STATE OF VERMONT AGENCY OF TRANSPORTATION

PROPOSED IMPROVEMENT TOWN OF CHESTER COUNTY OF WINDSOR VT 103 - PRINCIPAL ARTERIAL

RECORD PLANS	
CONTRACTOR:	MORRILL CONSTRUCTION INC.- NORTH HAVERHILL, NH
RESIDENT ENGINEER:	DAN BREER
CONSTRUCTION BEGAN:	MARCH 25, 2010
CONSTRUCTION COMPLETE:	AUGUST 10, 2010
RECORD PLANS BY:	DAN BREER & NICK GARBACIK
I HEREBY CERTIFY THAT ALL THE CONSTRUCTION REQUIRED BY THIS SET OF DRAWINGS HAS BEEN ACCOMPLISHED AS INDICATED HEREIN.	
BY:	<i>D. Breer</i> RESIDENT ENGINEER
DATE:	7/1/13
NOTE: Any further information concerning final quantities, amounts or other details relative to this project may be found at Central Files in the electronic archives.

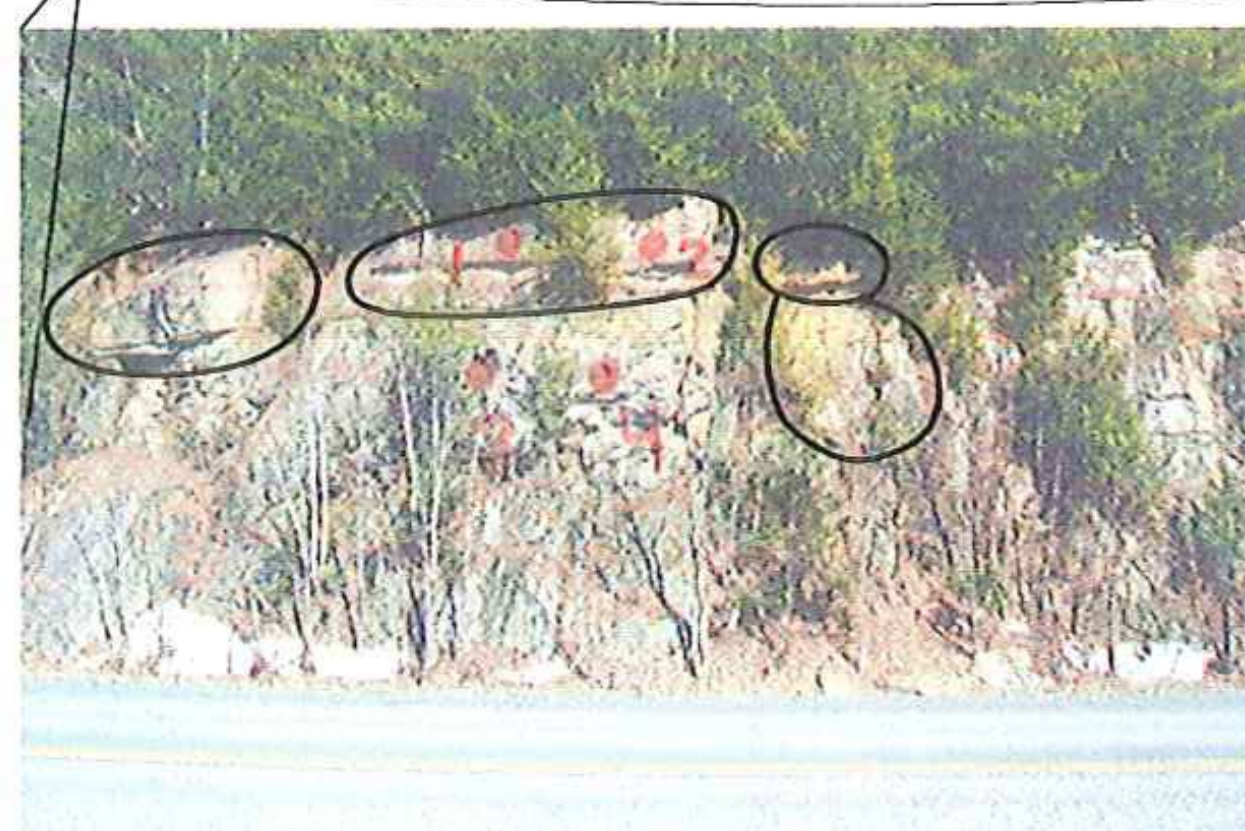
VOID
USE NEW COLORED COPIES
12/10/09
Key
o = Rock Dowel
x = Rock Dowel

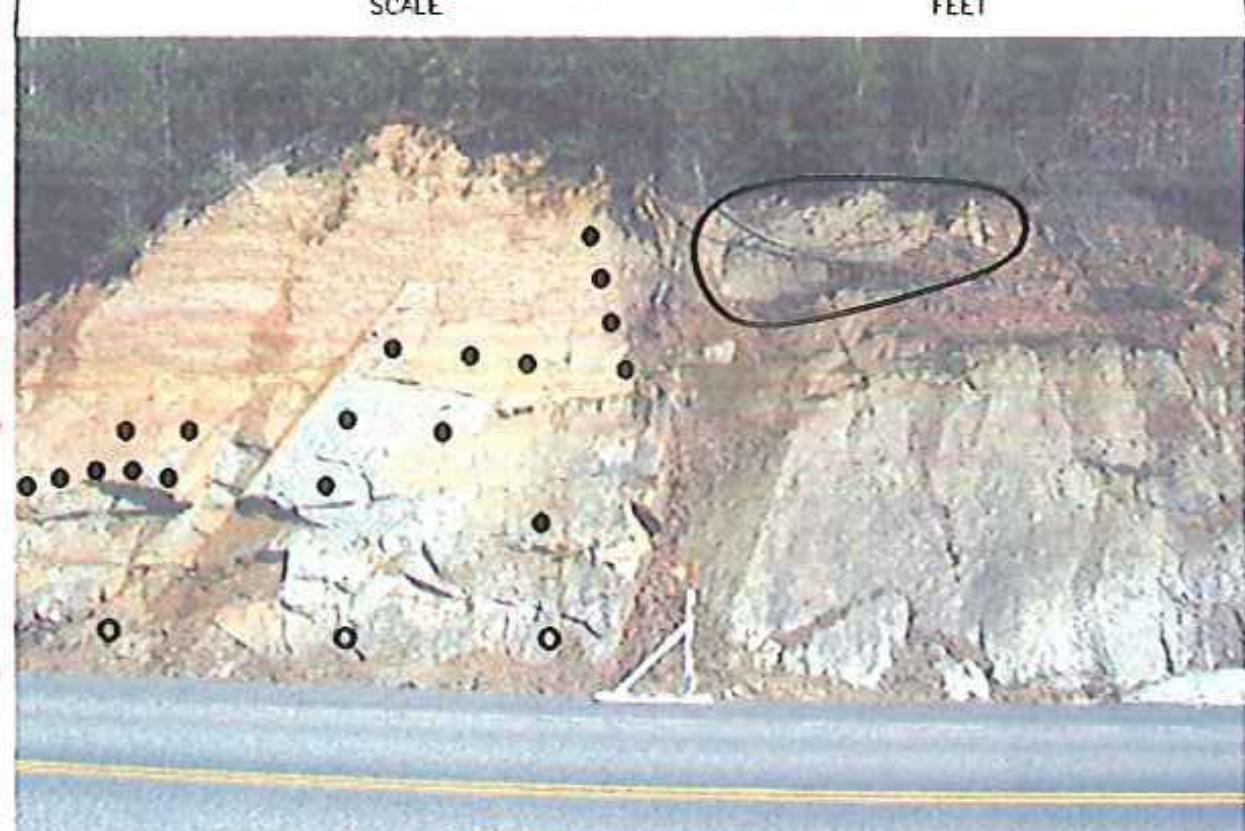
VOID

Chester NH 025-1(41)
August 10, 2010
Drain Holes

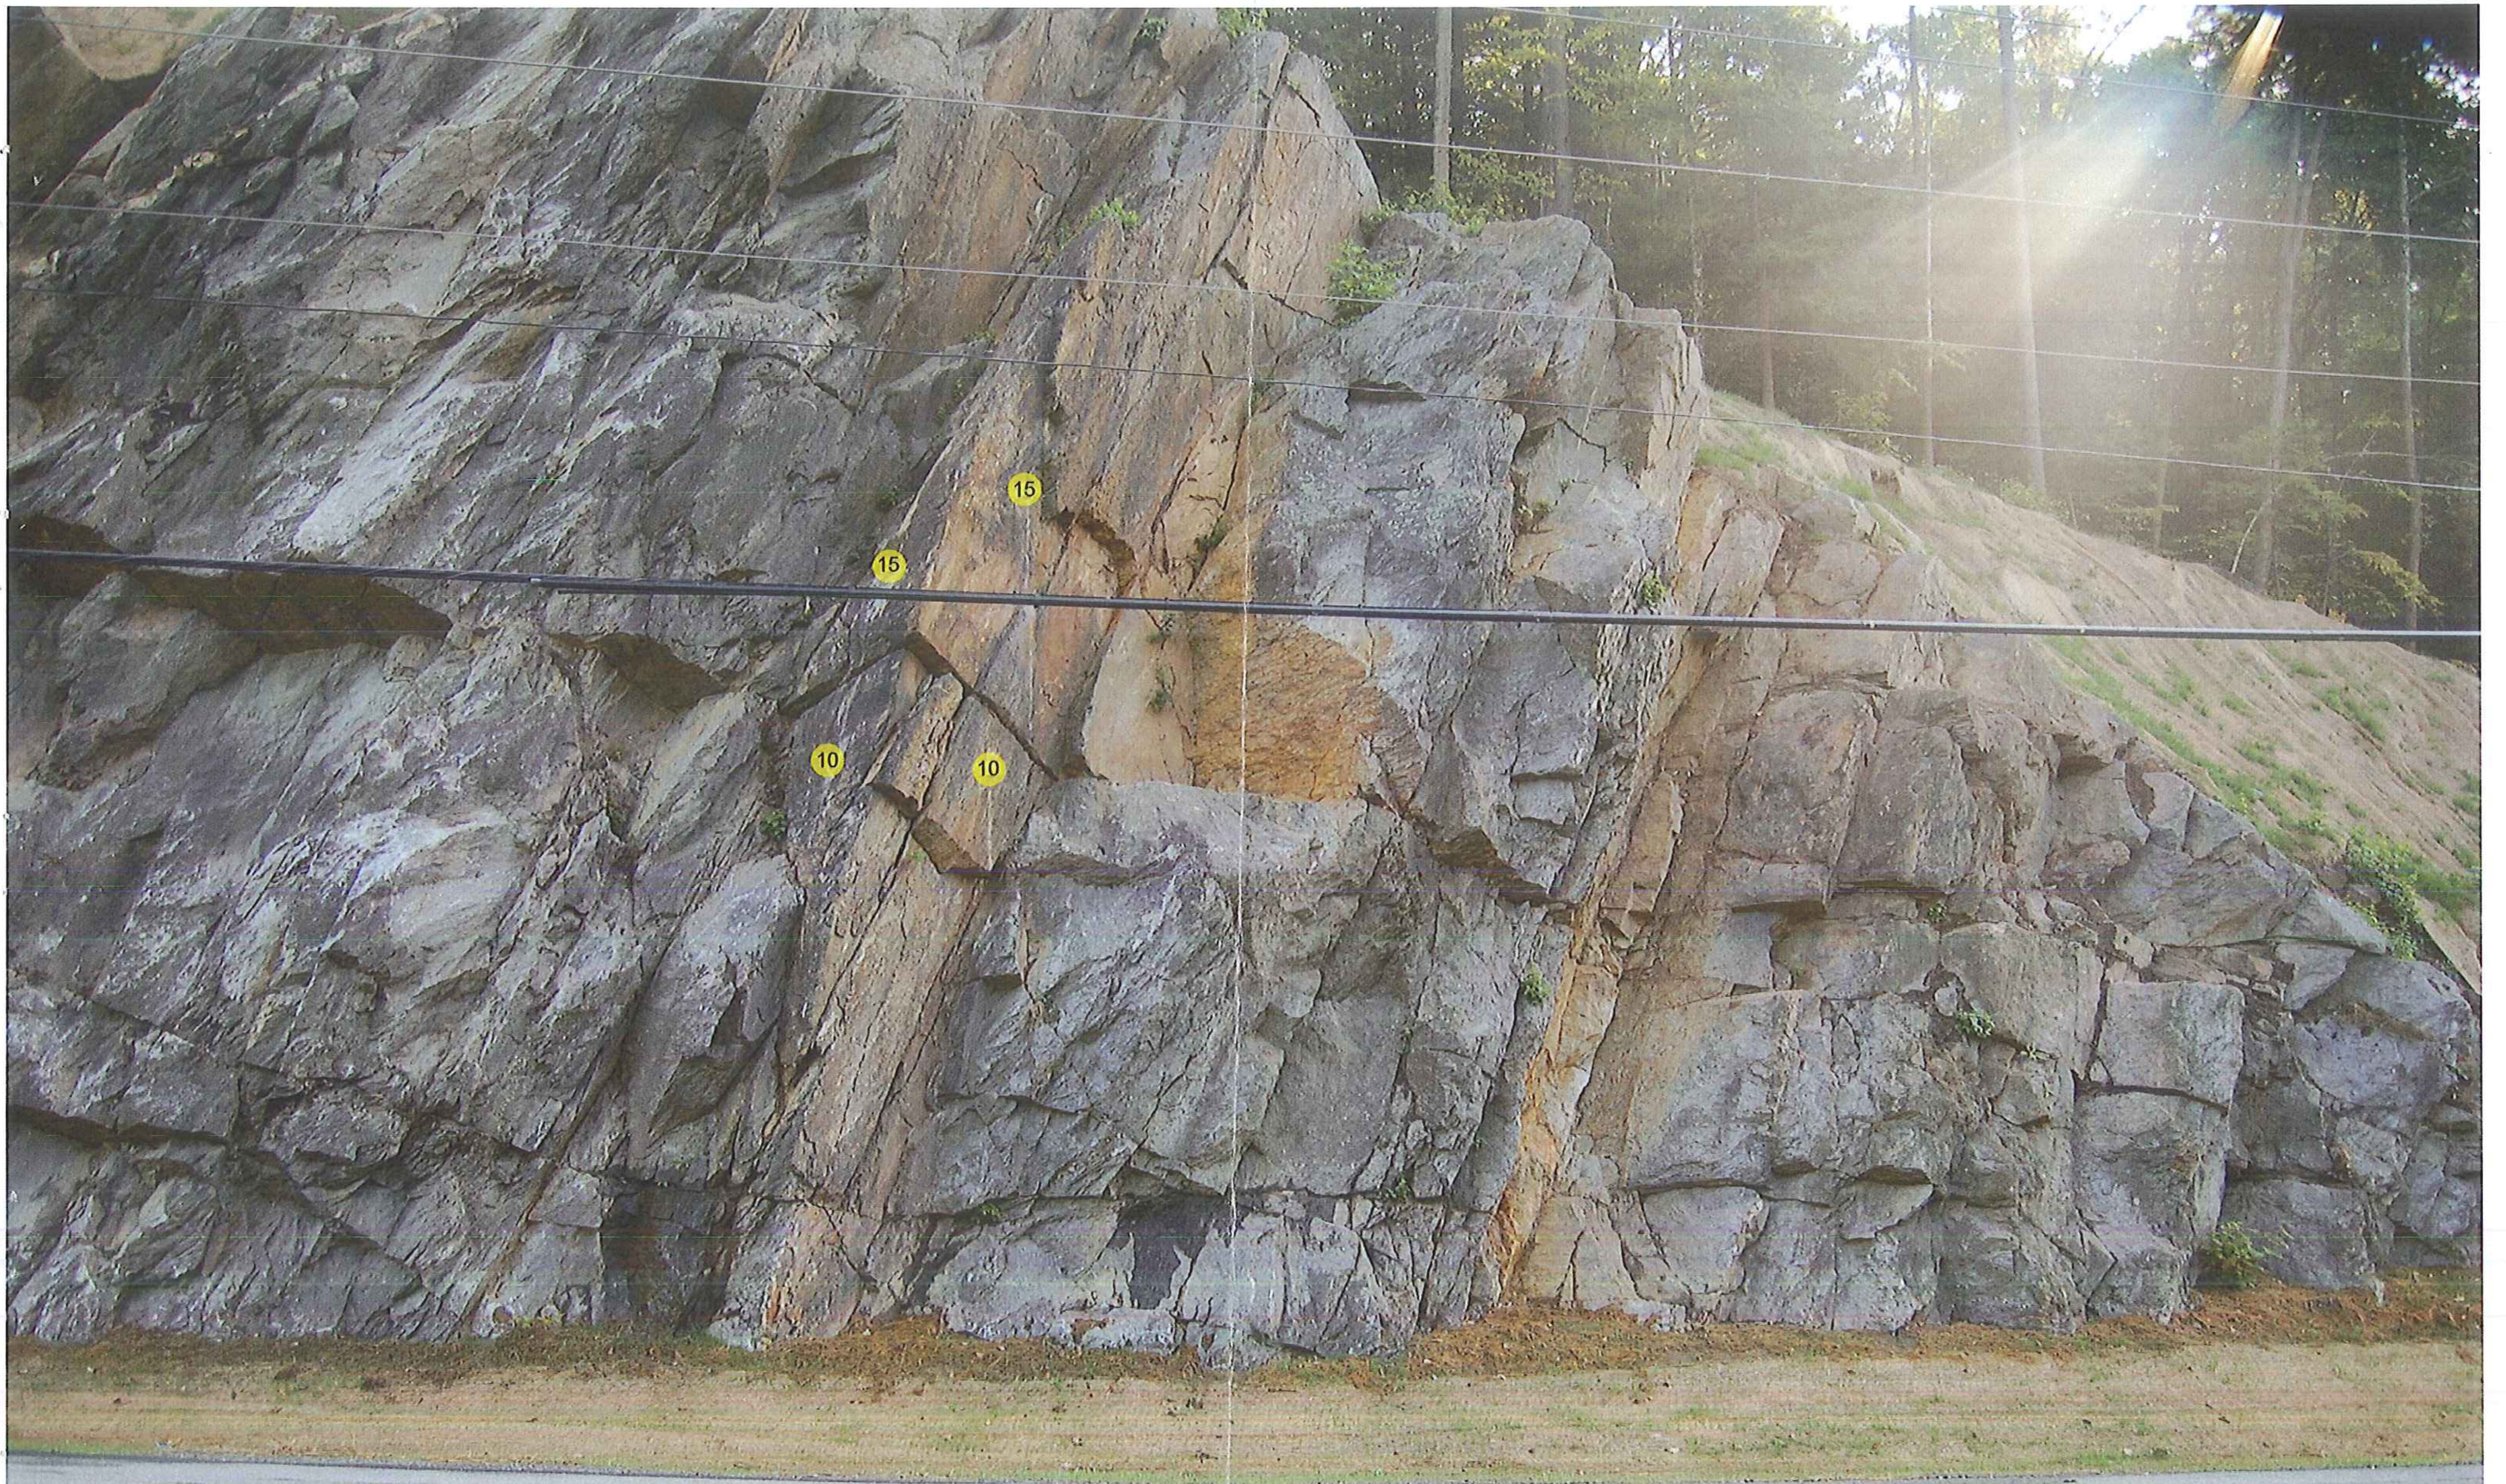
● Depth = 17" to Soil
Dry
10 Deg.

● Depth = 14" to Soil
Wet
10 Deg.

● Depth = 18" (No soil or Rock)
30 Deg.

● ● Depth = 12" to Rock
Dry
10 Deg.

● Depth = 12" to Soil
Dry
30 Deg.

● ● Depth = 18" (No Soil or Rock)
30 Deg.

● Depth = 5" to Soil
Dry
30 Deg.
